RELEASED FOR CONSTRUCTION
As Noted on Plan Review

DRAWING NUMBER
FP.1

· 1460 Broadway ·
1460 SE Broadway Dr
Lee's Summit, MO 64081

Fire Protection Plan

· Overhead Piping Plan ·

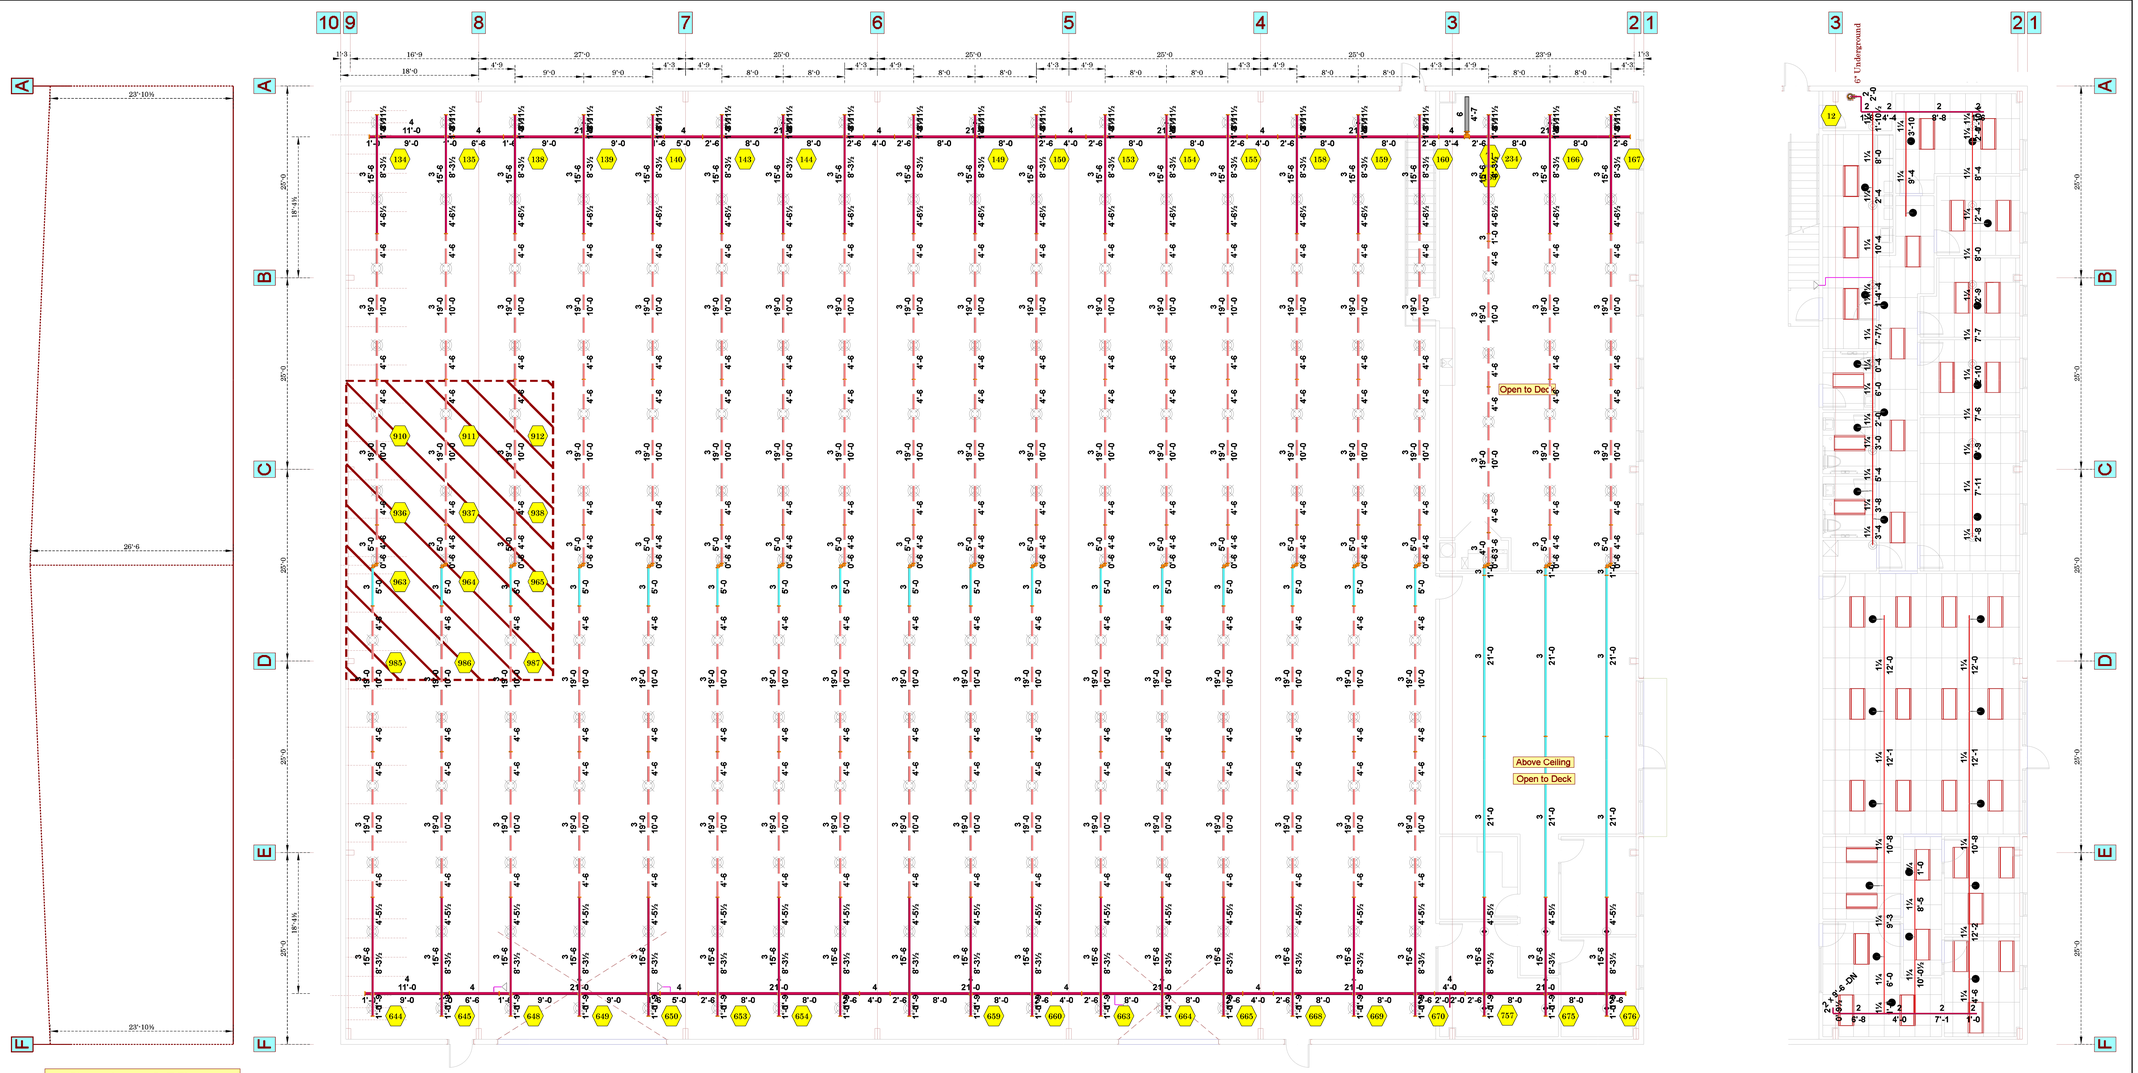
- HVLS Fans locations to be adjusted Relocated
